*Application Serial No.: 10/713,040*  
*Art Unit: 3618*

**Amendments to the Drawings:**

Appl. No. 10/713,040  
Art Unit 3618  
Customer No. 37833  
Confirmation No. 1144  
Annotated Sheet Showing Changes

*Fig. 1*

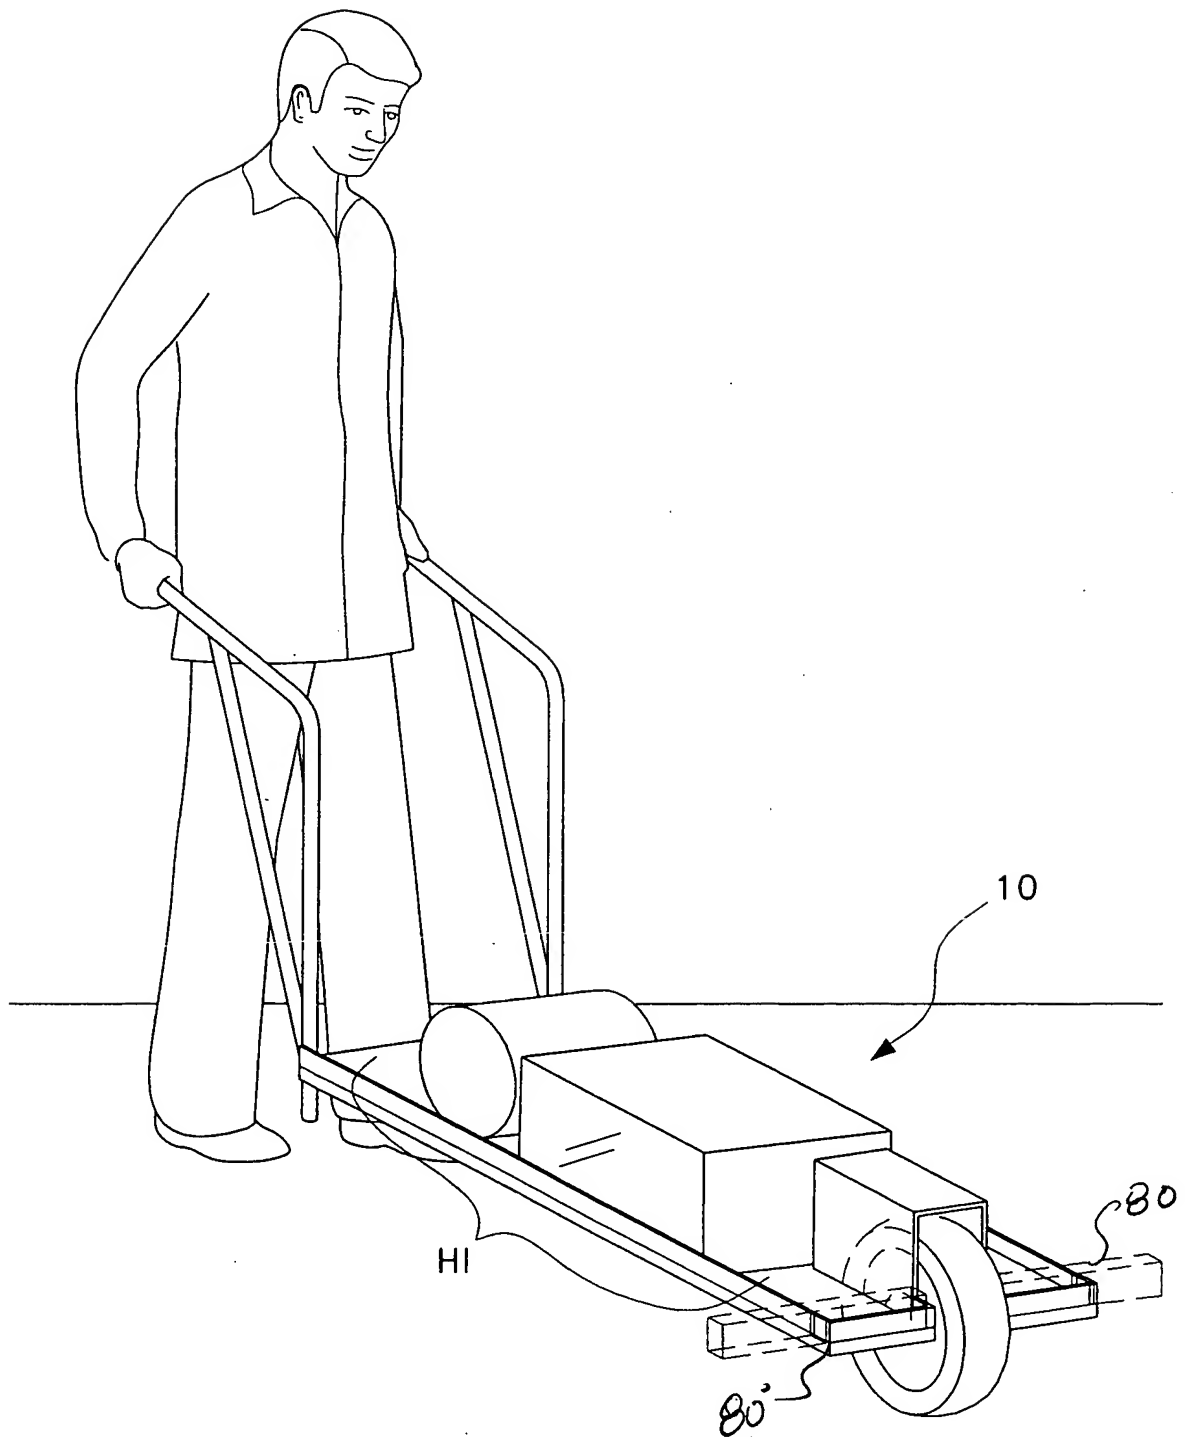
A proposed drawing change is submitted herewith. Proposed changes are shown in red. The attached sheet of drawings includes changes to Fig. 1. This sheet, which includes Fig. 1, replaces the original sheet including Fig. 1. In Fig. 1, reference characters -- 80 -- (designating the horizontal bar) and -- 80' -- (designating the slot) have been added.

The Examiner objected to the drawings under 37 C.F.R. § 1.83(a) because certain claimed features were not shown in the drawings. Specifically, the 3" high board of Claim 2, and the fitted groove of the horizontal bars of Claim 12 have not been shown. Applicant has canceled Claim 2, thus rendering this objection moot. The drawings have been corrected to show the fitted grooves 80' (see corrected Fig. 1). Applicant submits that this
